APPEAL SUMMARY

Appeal ID: 22157

Project Address: 5510 N Denver Ave

RECONSIDERATION OF APPEAL ID:
22001

a8.01

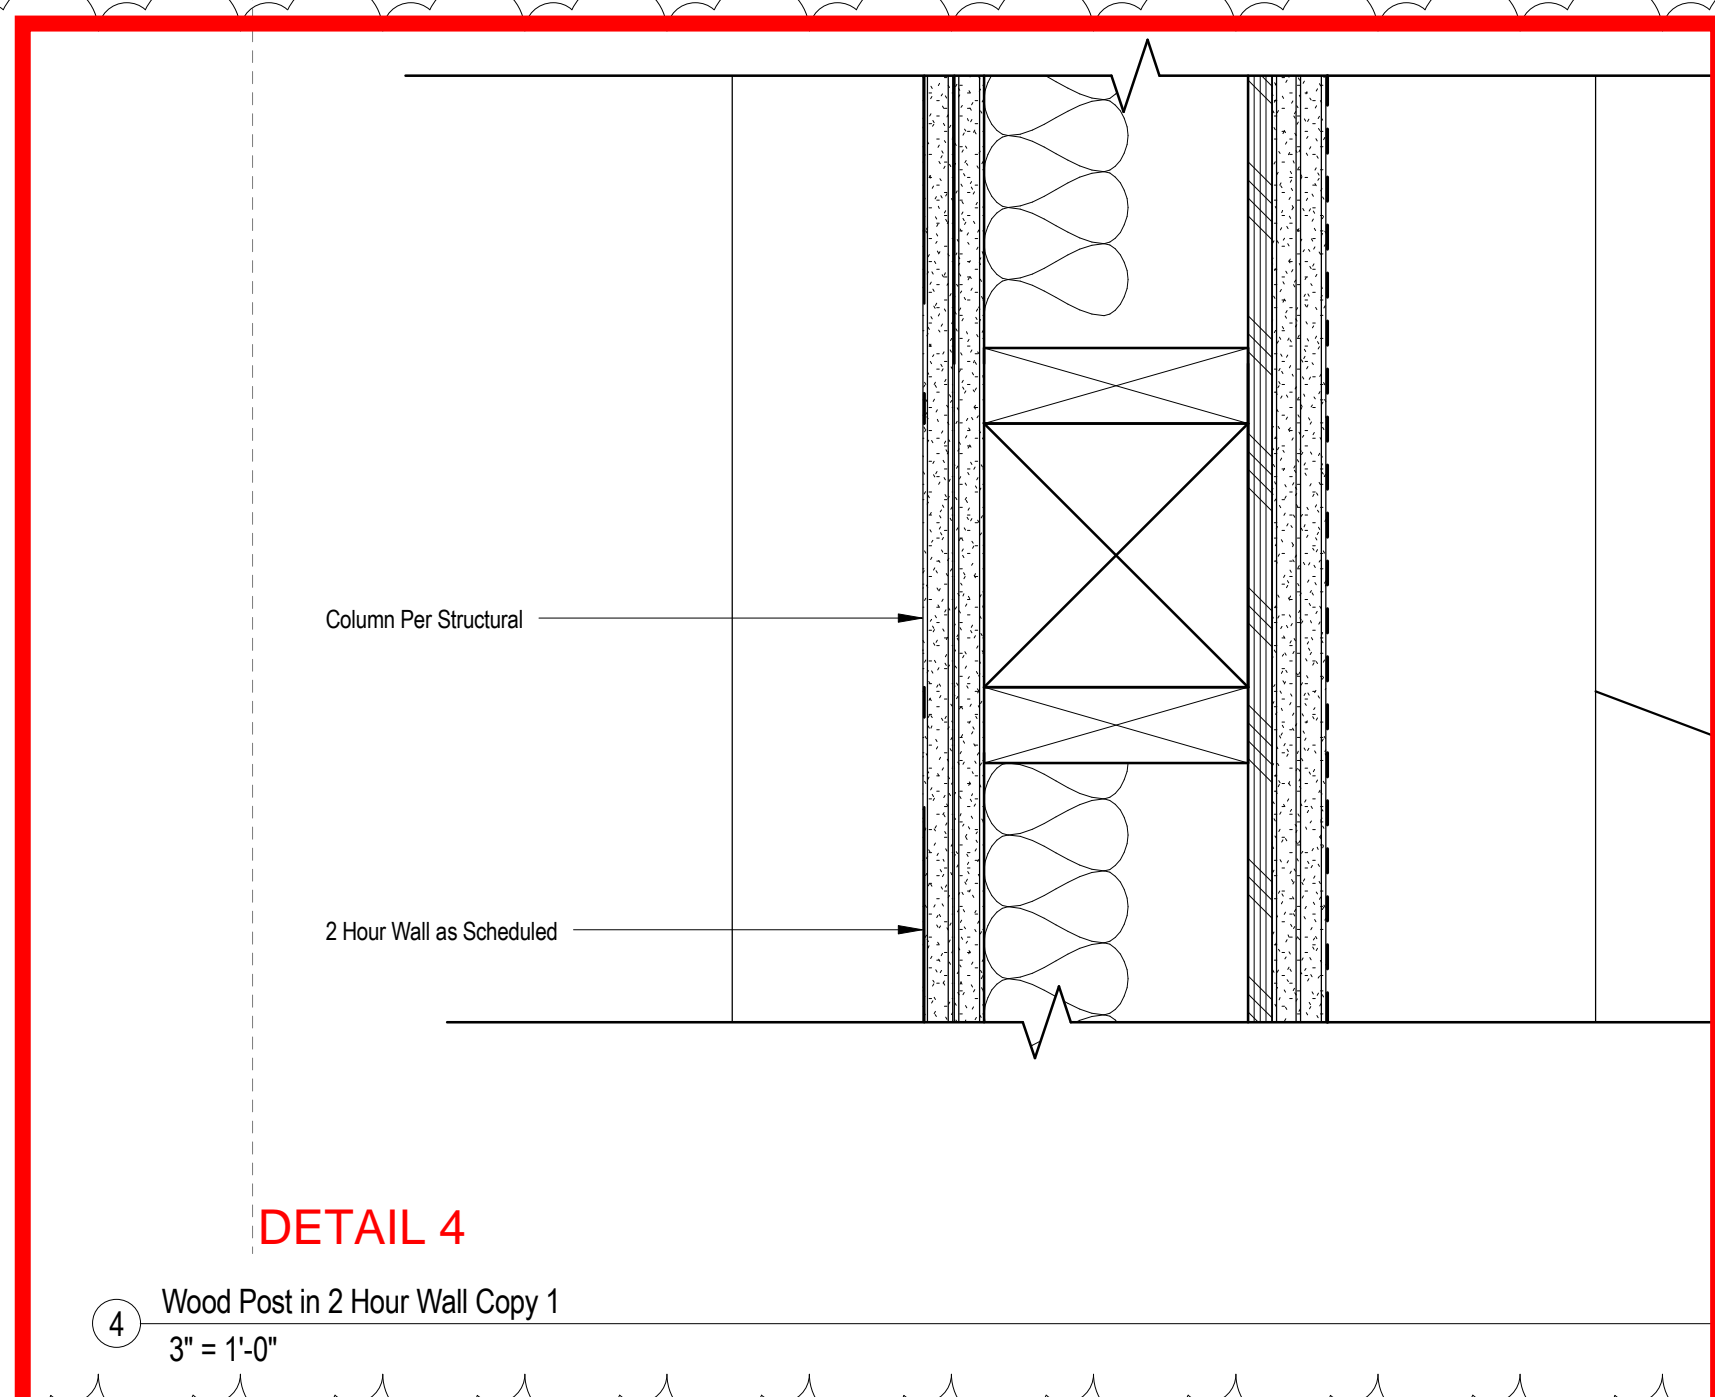
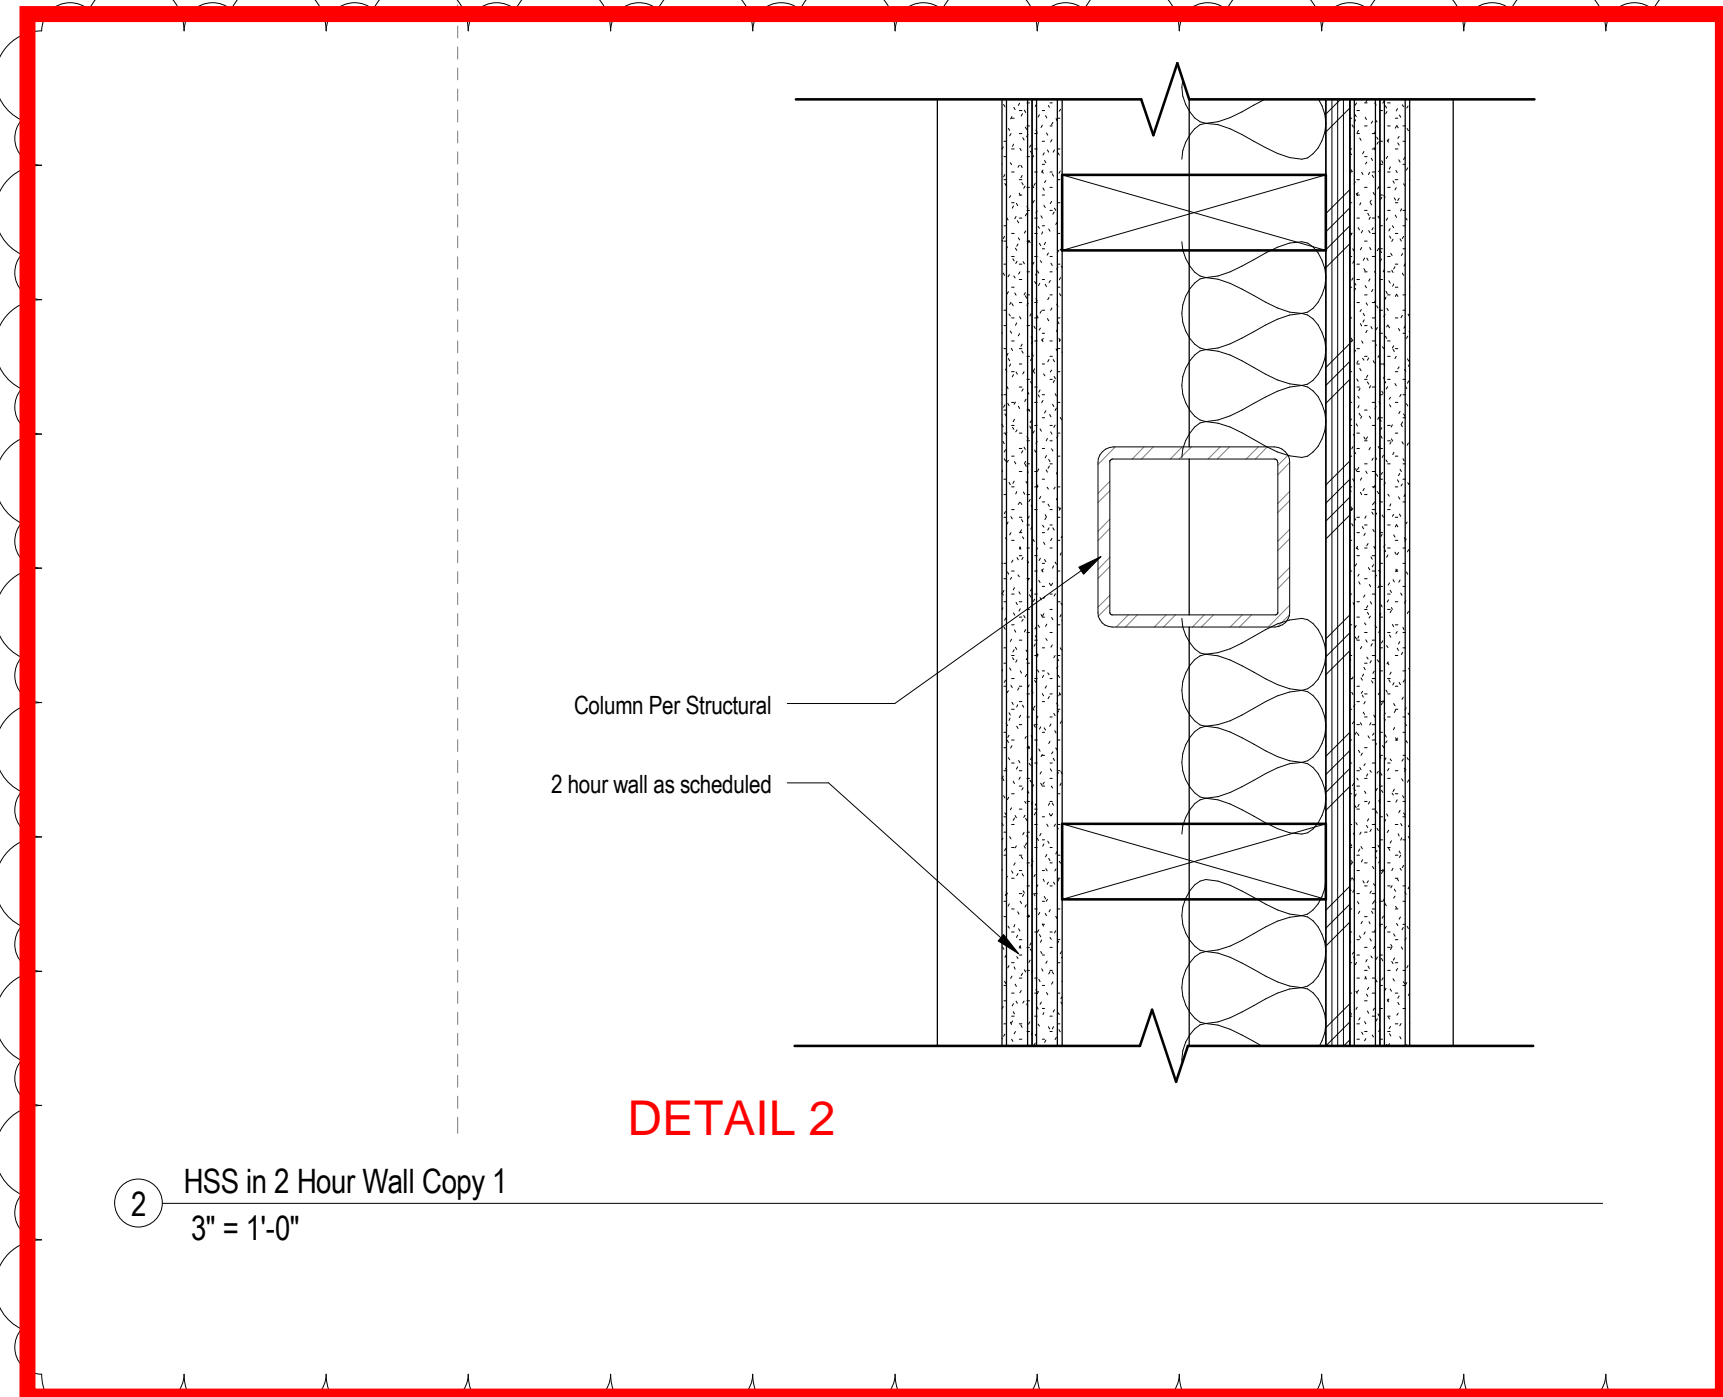
The details shown on a8.01, Exhibit 5, details 12 and 13 show the head details for the condition with and without glulam beam.

We were also asked to demonstrate that the post can be in-line with the wall, which is now the case with the revised details (previously the gypsum wrap was pushing the post out of line with the wall).
